## **AGENDA FOR REGULAR MEETING VILLAGE OF TINLEY PARK PLAN COMMISSION**

**ITEM #1      WORKSHOP – RJ’S SEAFOOD BUILDING ADDITION AND PATIO, 18201  
HARLEM AVENUE – SPECIAL USE FOR PUD AND SITE  
PLAN/ARCHITECTUAL APPROVAL**

# PLAN COMMISSION STAFF REPORT

Site Plan (Overall & Detail)

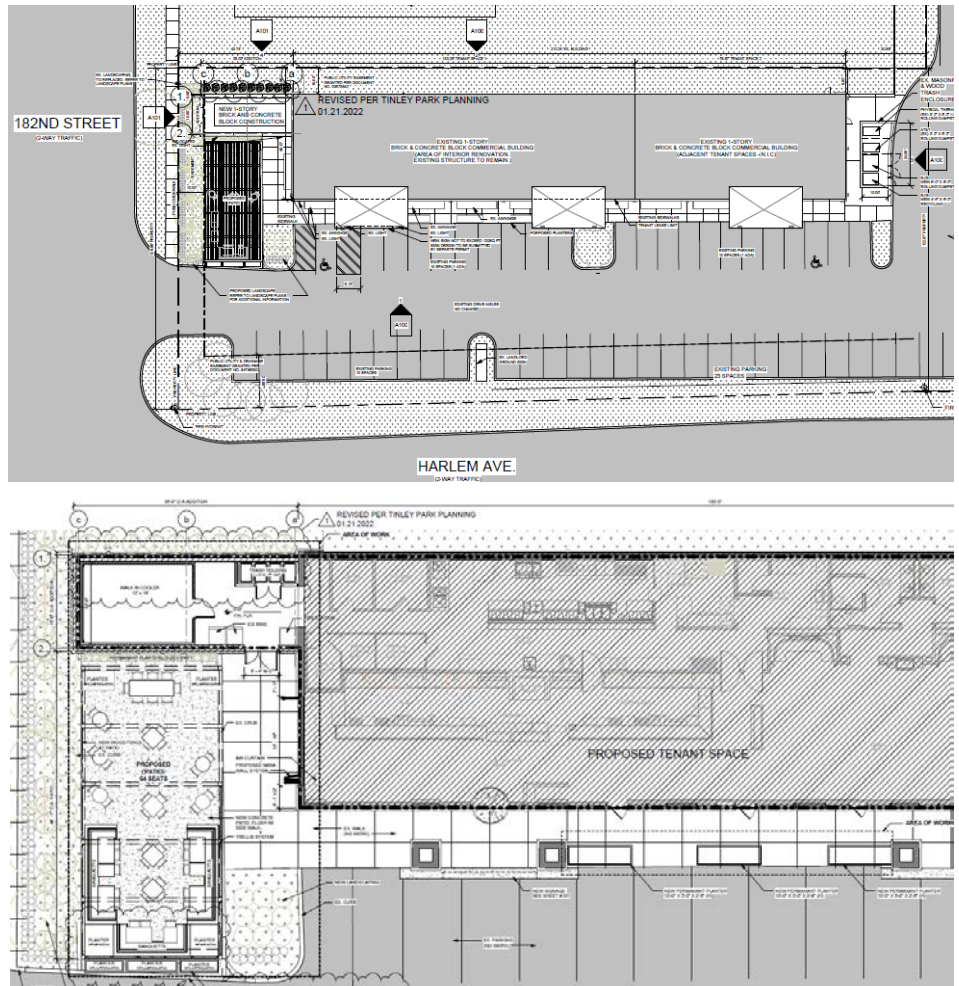
The applicant has provided overall and detail site plans which indicate the areas of work at the north end of the building facing 182<sup>nd</sup> Street. The 525 sq. ft. building addition (35'x15") and 1120 sq. ft. concrete patio (22'-0" x angled 50'-6" to 51'-6") will be between the building's north surrounding walkway. It is positioned to be setback 10 feet from the north property line. The concrete patio includes open seating and banquette within the trellis, as well as a 62 sq. ft. planter area outside the trellis. The rear (east) wall of the addition will be flush with the existing building. Between the patio's west edge and drive aisle there will be permanent fibre glass reinforced planters and a 9-inch concrete barrier curb. More permanent planters are proposed at the addition's west wall (sizes vary) and on the inside corners of the patio's trellis. Also, three large planters are proposed further south on the building's west (front) surrounding walkway. Fencing is proposed around the north, west, and part of the south sides of the patio.

**Open Item #1: Confirm and note the square footage of building addition and concrete patio on the site plan.**

**Open Item #2: Staff is recommending the site plan approval be conditioned upon final engineering and Building Department review and approval.**

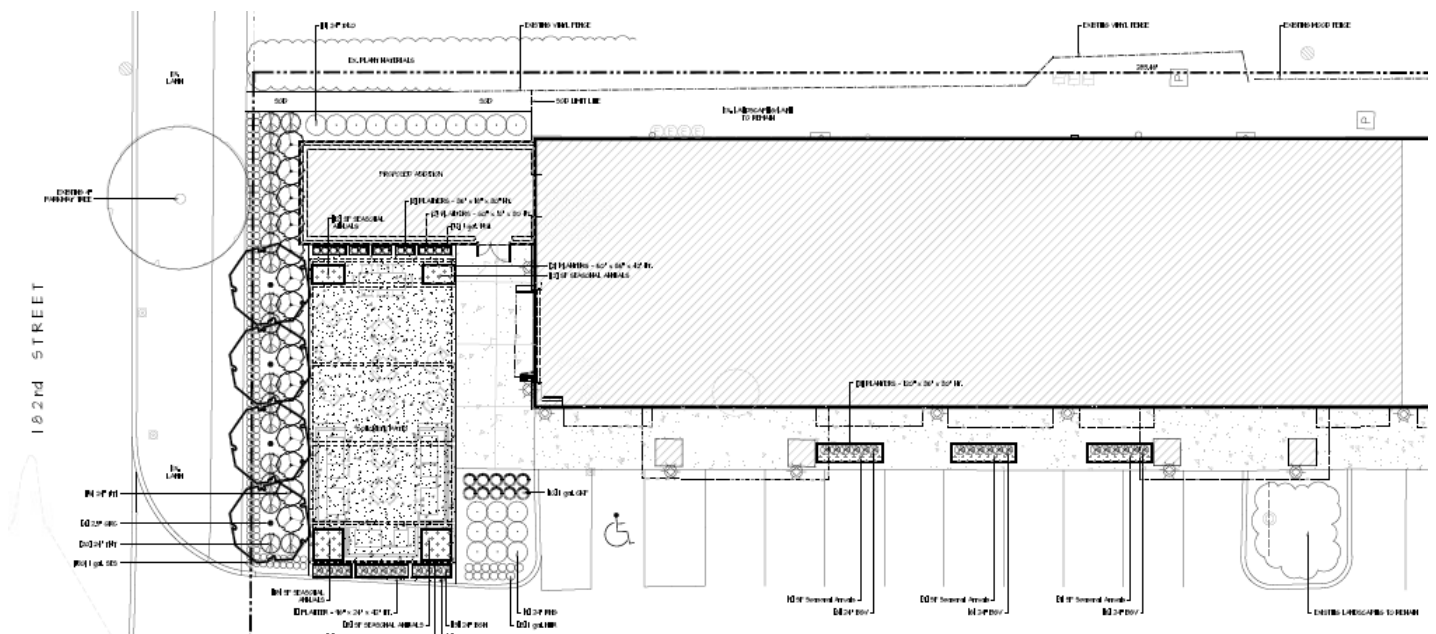
**Open Item #4: Discuss the proposed screening (landscaping and fencing) from the nearby residences.**

**Open Item #5: Discuss height of piglet dwarf fountain grass on the addition's west wall.**

*Proposed Rendering Looking East*

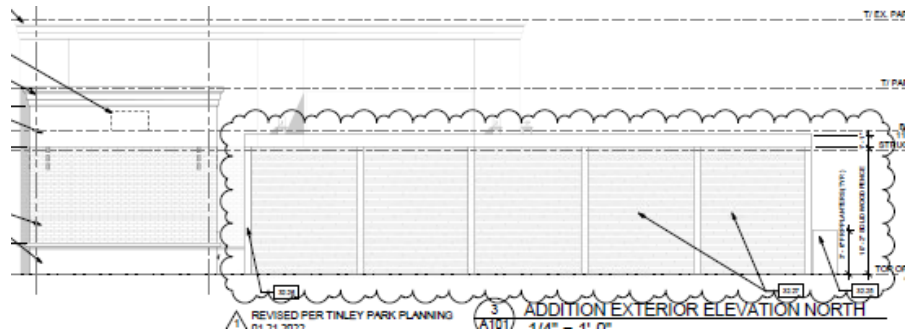
There is some variety of color and design from the proposal to the existing building. Though the Nanawall partition framing and the building addition (stucco, brick, and stone) will be similar to the existing building, the patio's planters and trellis are proposed black, and the fence's color is a dark walnut (likely darker than the renderings portray). The black will be similar to the existing building's black awnings, but the visual effect of the color should be considered given the scale of trellis, fencing, and planters.

**Open Item #6: Discuss the architectural compatibility (color, aesthetics, etc.) among the proposed site improvements (addition, patio, fencing with trellis, planters) and the existing building. Consider the height of the north fence wall.**

**Open Item #7: Confirm/correct heights of patio planters on the drawings.**

**Open Item #8: Discuss the design and permanence of three large walkway planters west of the existing tenant space in relation to potential additional planters throughout the development.**
